RESPONSE TO RFI

LONGVIEW NEIGHBOURHOOD 7 LRD

Ballyvolane, Cork
– September 2026

A Request for Further Information was issued on 19/08/2026. This document will explain how the various architectural queries are to be answered.

Clip from drawing 2326 – 112 showing current conditions on site

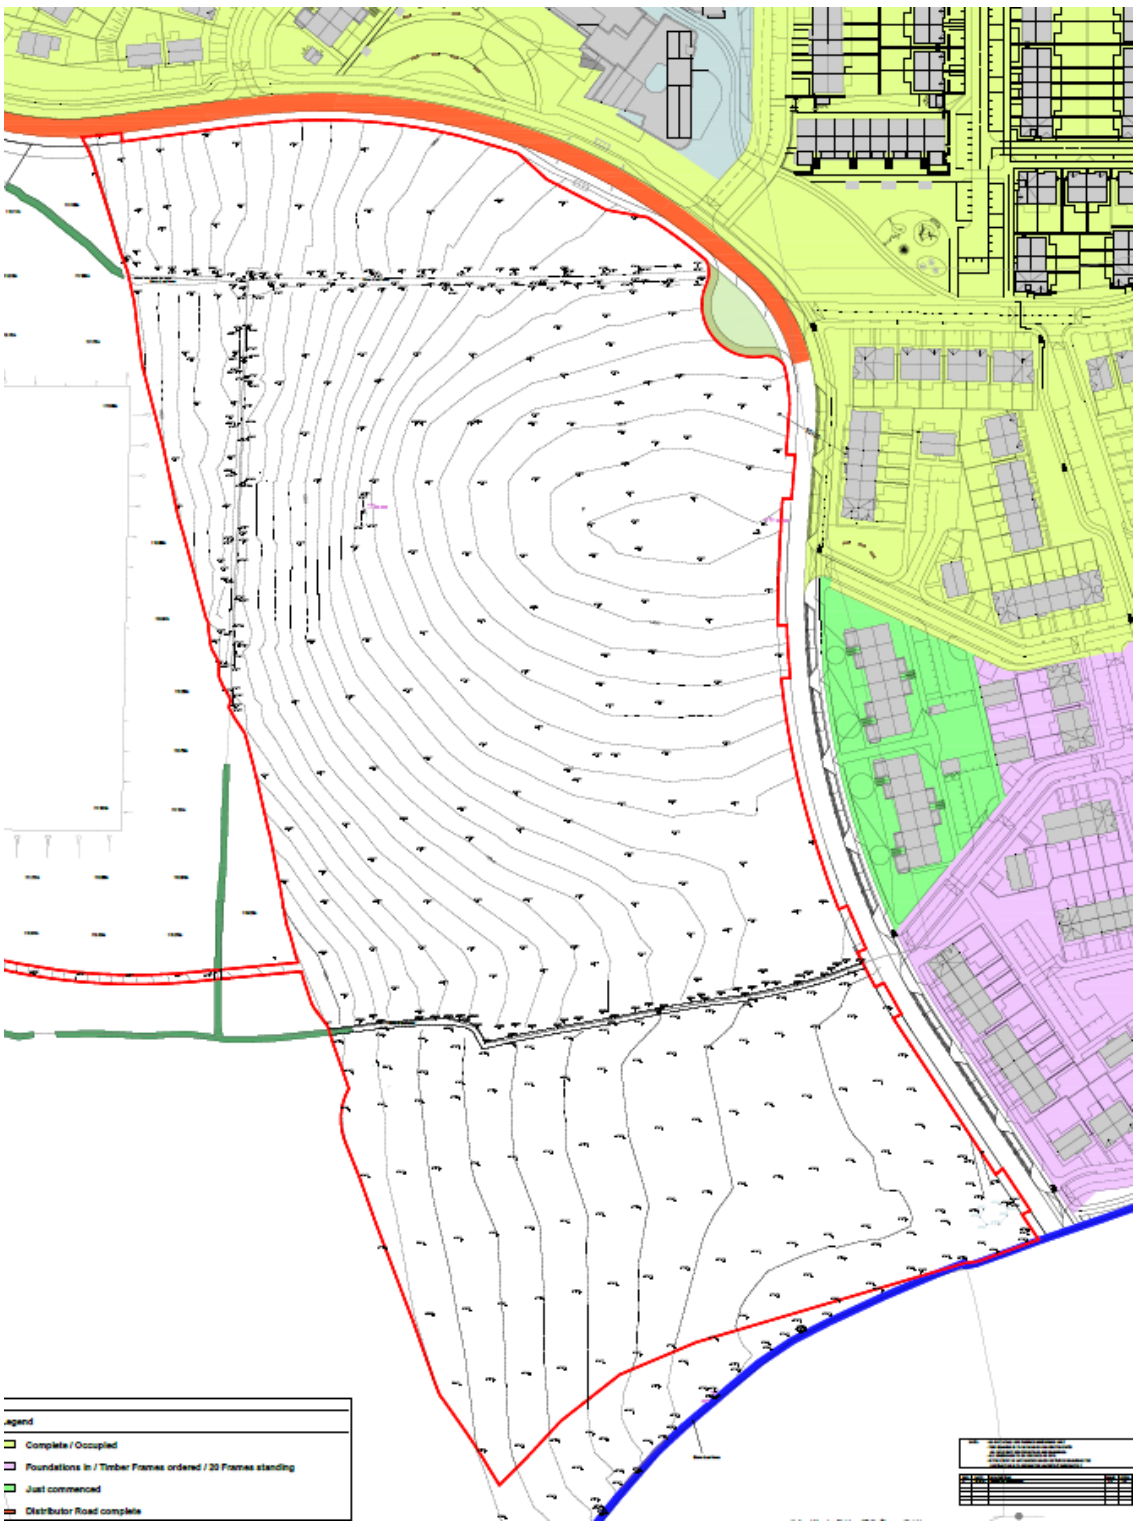
"No site Survey showing existing levels across the site have been submitted. No indication of the extent of cut and fill proposed is indicated on site sections or elevations. There are few level details on proposed site plan – only FFL no adjacent levels to show topography."

In order to aid in the assessment of this application please submit:

- a. A site survey showing existing levels across the site, and*
- b. Updated site sections and elevations to show existing and proposed levels, including full extent of all cut and fill"*

Existing Site Layout plans have now been included with this submission. Drawings no: 2326 - 112 & 2326 – 113 show the site survey including contours and spot heights. The Site Sections (2326 – 300) and the Site Elevations (2326 – 400) now include a line showing the existing ground level in blue. For further details on the quantum of cut & fill please refer to MHLs drawings and documents.

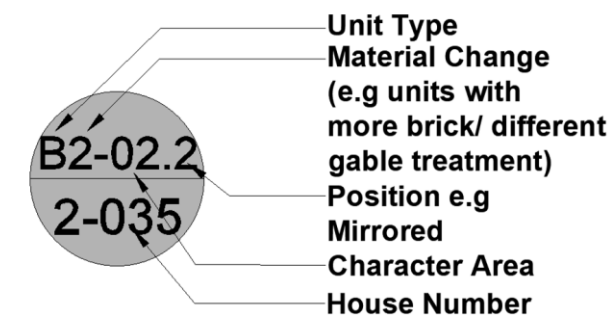
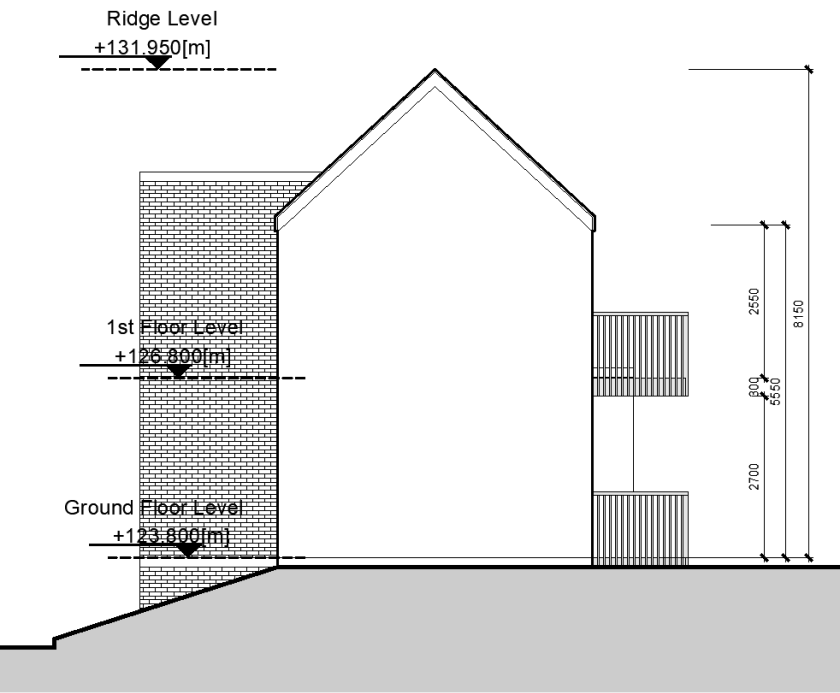
"Similiarly, the site plans show that house type B1-02 has a different footprint orientation for unit no.s 2-008 and 2-009 but only one version of the floor plan and elevations has been submitted (Drawing no.s 2326-B2-002-200 and 2326-B2-002-400)."

"Accordingly, please review all plans and ensure that they are legible and, where mirrored or flipped, that floor plans for every iteration are submitted"

New housetype numbers have been created to better reflect the various situations occurring across the site. Each new housetype has a corresponding set of plans and elevations.

Units have been reviewed and naming system revised to improve legibility and clarity.

Clip from drawing 2326 - C - 200 showing windows removed from Block C

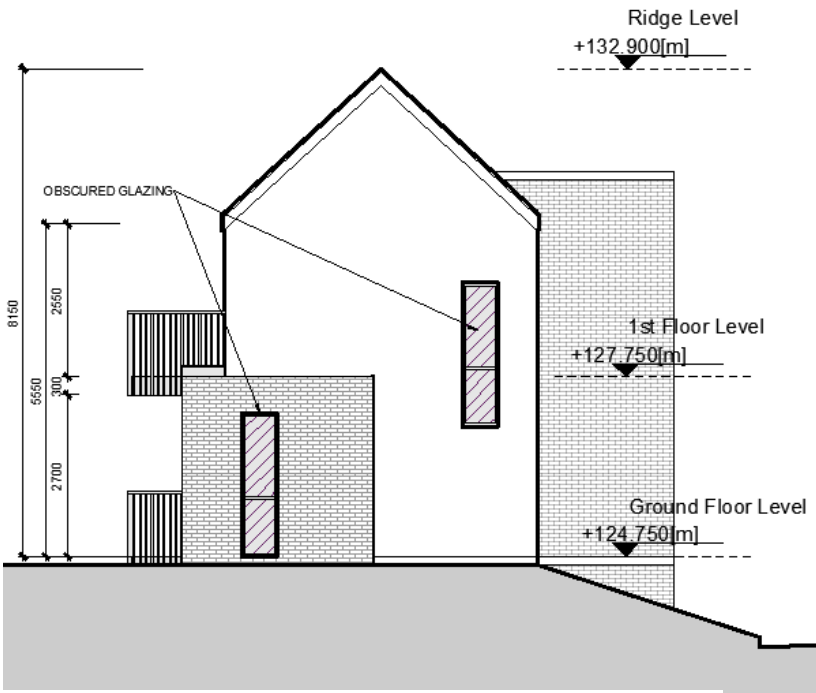
"The window on the western elevation of Block C and eastern elevation of Block D will be intervisible with windows serving apartments in Blocks A and B. Please address, noting that the omission of the windows on Block C and the making obscure of the windows in Block D may sufficiently protect amenity."

The windows on the western elevation of C have been removed and the windows on the eastern elevation of Block D have been made opaque to improve amenity.

a. Footpaths extended to 2 metres wide highlighted in pink

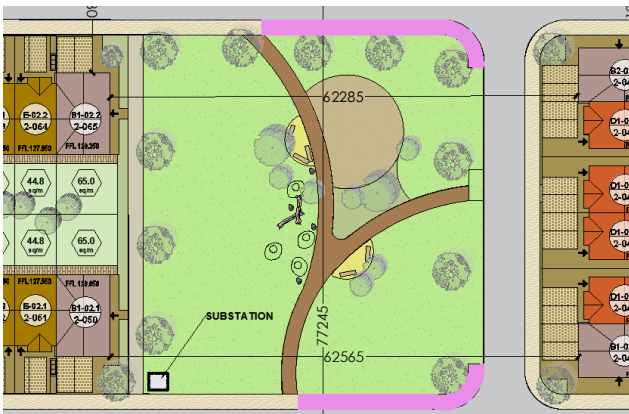
"a. The road network serving the southern section of the proposed development requires revisiting to ensure 2.0-metre-wide footpaths are provided along the access roads connection with Longview Estate Distributor Road:"

Footpaths have been revised to be 2 metres wide.

c(iv). Parking reduced in southern public open space

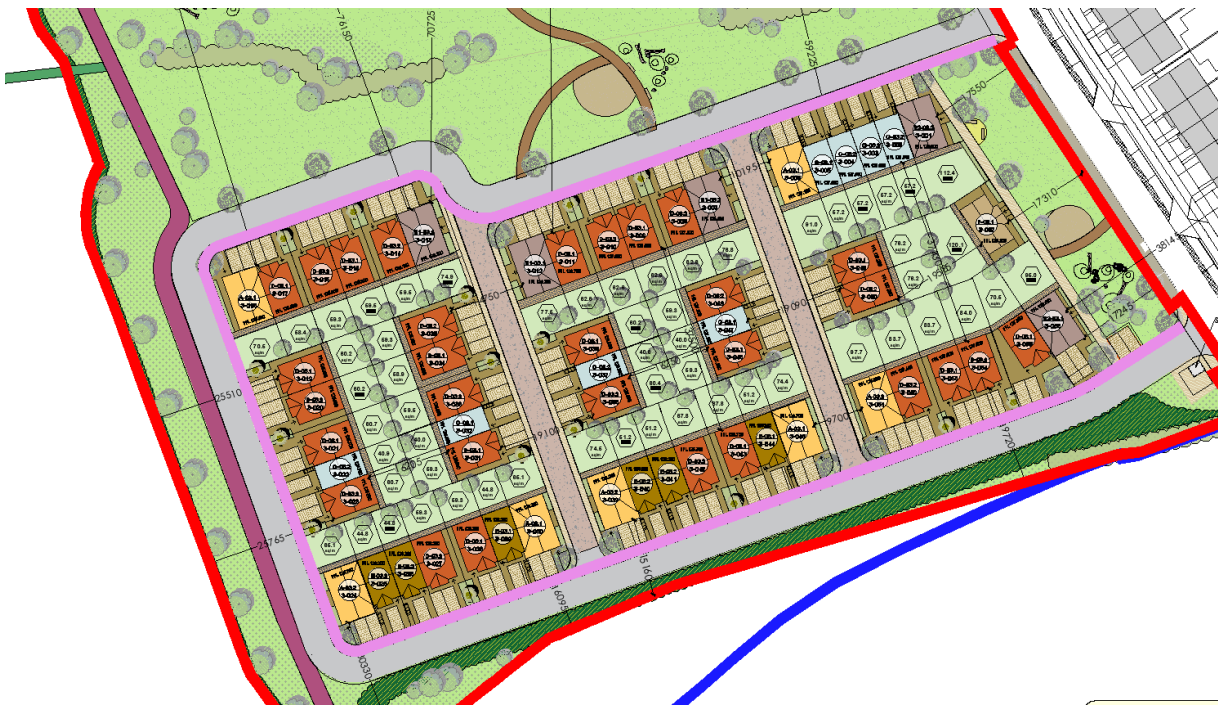
(i) Footpath travelling along the northern and southern boundary of the central public open space opposite residential units 076-072 and 023-027;"

(iv) The removal of the 8 parking bays from within the public open space opposite residential units 001 and 059-062 and their replacement with 5 parking bays to the west of the substation along the southern boundary of the site ;

These footpaths have been extended as requested.

All but 2 of these parking bays have been removed. The remaining two are to be the designated property of house 3-057.
